Annex – 1 Issues with the potential for negative implications for the River Spey SAC specifically relating to the Peat Slide Risk Assessment and construction and operation of wind farm tracks and turbines within the upland peat habitat.

Chapter 7: Project Description;

Figure 3 – location of water crossing point between turbines 67 -52

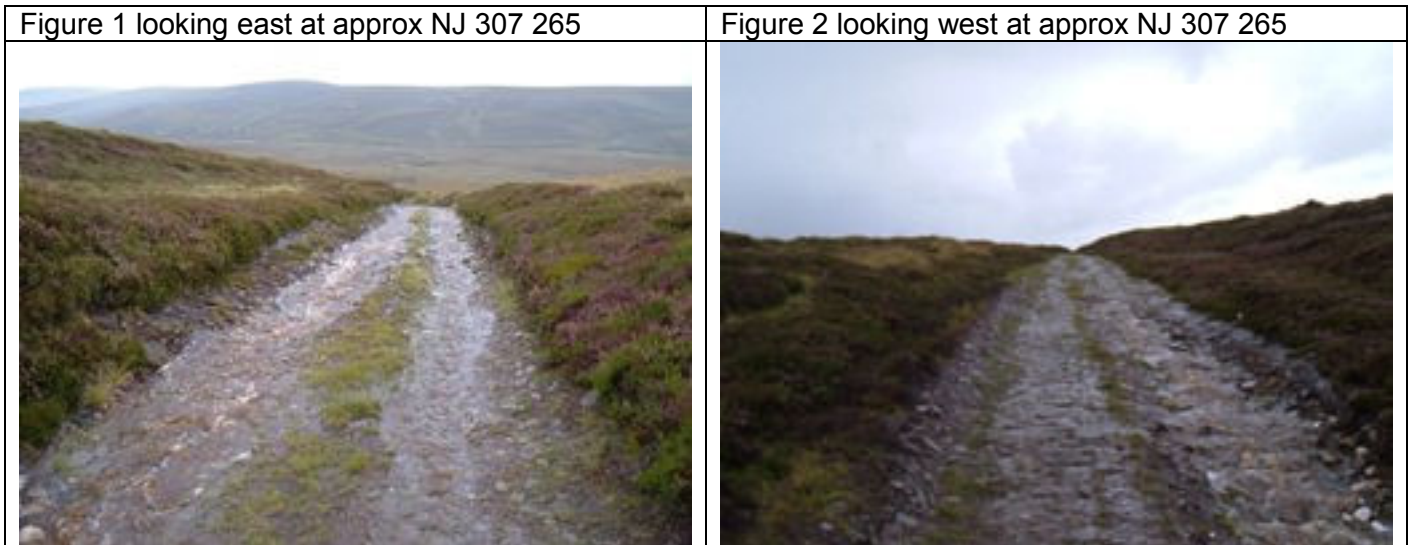
- 1.44 *Photos from site visit (10 August 2008)*
Figures 1 and 2 below show the section of existing access track during an abrupt summer downpour in August. It is acting as a fast-flowing conduit for runoff. It was noted during the rainfall event that the natural streams within the hillside did not increase rapidly in flow, but that most of the existing tracks did act to speed the water quickly down the hillside and into the

main rivers. This occurred even when the tracks had a relatively shallow gradient. There is clearly an impact on habitats adjacent to these tracks where water eventually breaks out onto vegetation or joins with a ford along the track. If traffic were to increase on these tracks it would very quickly destabilise the base and result in heavily discoloured runoff into the streams. Currently, traffic levels are so low, the runoff was relatively clear. The potential for impacts on the River Spey from runoff from a more extensive network of tracks is of high concern and must be assessed more thoroughly.

Figure 3 shows the approximate location of the water crossing and track alignment that is causing us some concern in terms of the amount of excavation and fill that would be required. It is evident that the stream to be crossed is capable of carrying quite significant sizes of bedload (figures 4 and 5) indicating that this is a high energy environment. Tracks within this area will also be subject to extremes of weather, including high runoff events. This is of concern because of the scale and duration of construction in this zone and because this stream runs into the River Spey SAC.

In addition, at this point approximately 120 deer were spotted and there was moderate to heavy grazing and poaching up this little valley. This could be contributing to the risk of peat slide here and may also, unless deer numbers are reduced, cause erosion problems for any tracks constructed in this area. The largest of the peat slides noted throughout the site (PS/4) can be seen higher up the valley and SNH is unconvinced that this is an appropriate area to have a looped track, water crossing and turbine on the flank up to the right of the photo and a further 2 to the left side of the valley.
